Appl. No. 10/573,331
Amdt. Dated December 22, 2008
Reply to Office Action of June 25, 2008

Amendments to the Drawings:

REMARKS/ARGUMENTS:

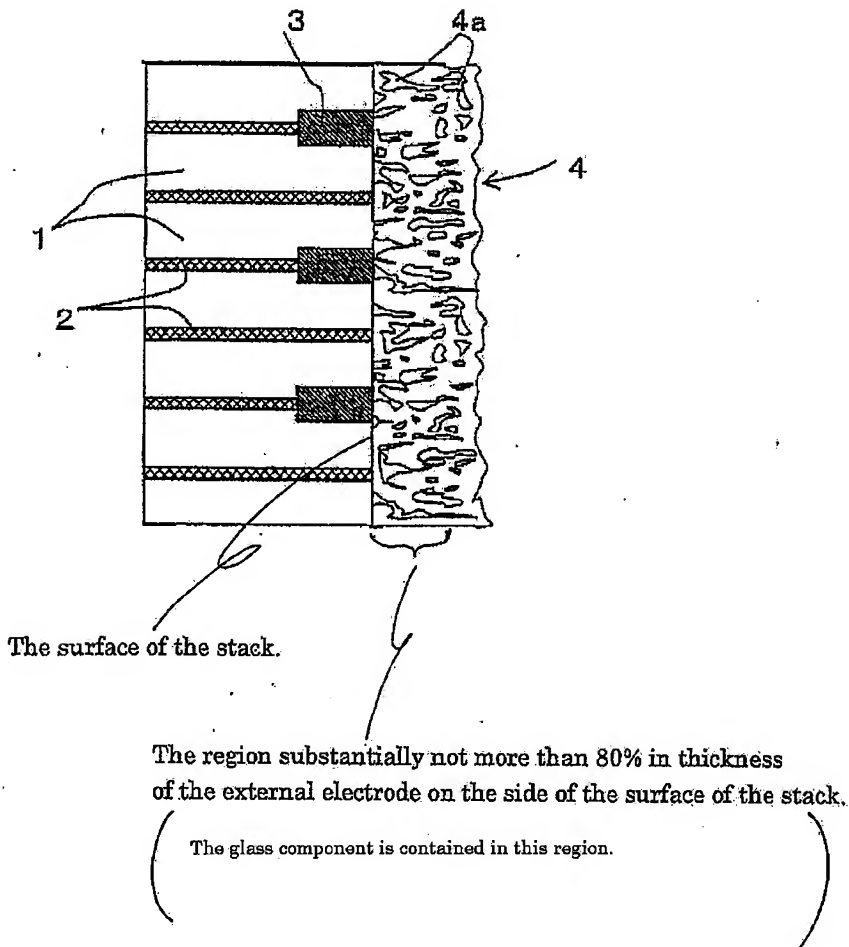
“It is unclear what is meant by ‘wherein the glass component contained in the external electrode exists in a region substantially not more than 80% in thickness of the external electrode on the side of the surface of the stack’.”

In response, Applicant changed “wherein the glass component contained in the external electrode exists in a region substantially not more than 80% in thickness of the external electrode on the side of the surface of the stack” to -- wherein the glass component is contained in a region substantially not more than 80% in thickness of the external electrode on the side of the surface of the stack--.

Claim 56 is further explained by the diagram below. Withdrawal of this rejection is thus respectfully requested.

Fig. 8A

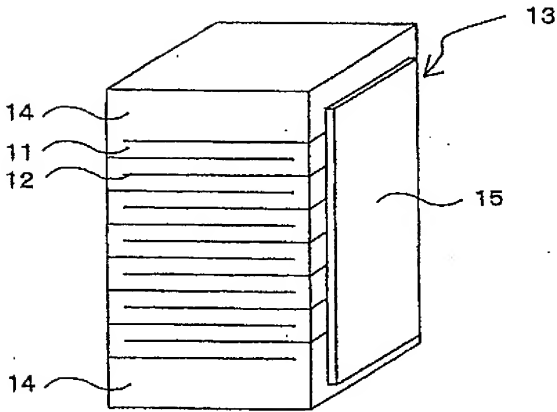
The Office states, "Figures 8A, 8B, and 9 should be designated by a legend such as --Prior Art-- because only that which is old is illustrated." In response, Applicant amended Figures 8A, 8B, and 9 to include the legend --Prior Art--. Withdrawal of this objection is thus respectfully requested.

The drawings stand objected to as failing to comply with 37 CFR 1.84(p)(5) because they include the following reference character(s) not mentioned in the description: 15, 51, 52, 53, 55, 61, and 70. In response, Applicant deleted reference characters 51, 52, 55, 61, and 70 from the drawings. In addition, Applicant included a description of reference characters 15 and 53 in the specification. Withdrawal of this objection is thus respectfully requested.

Fig. 6

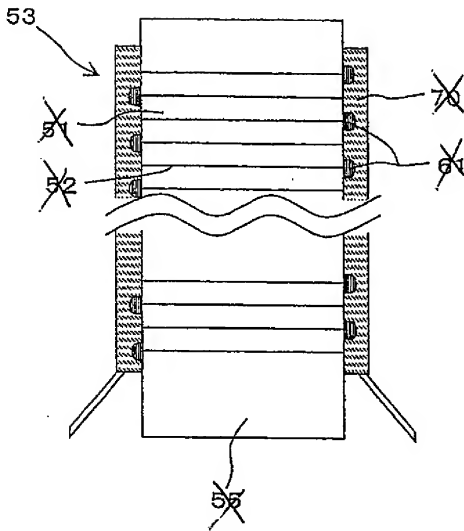
The attached Annotated and Replacement sheets include changes to Figures 6, 8A, 8B, and 9.
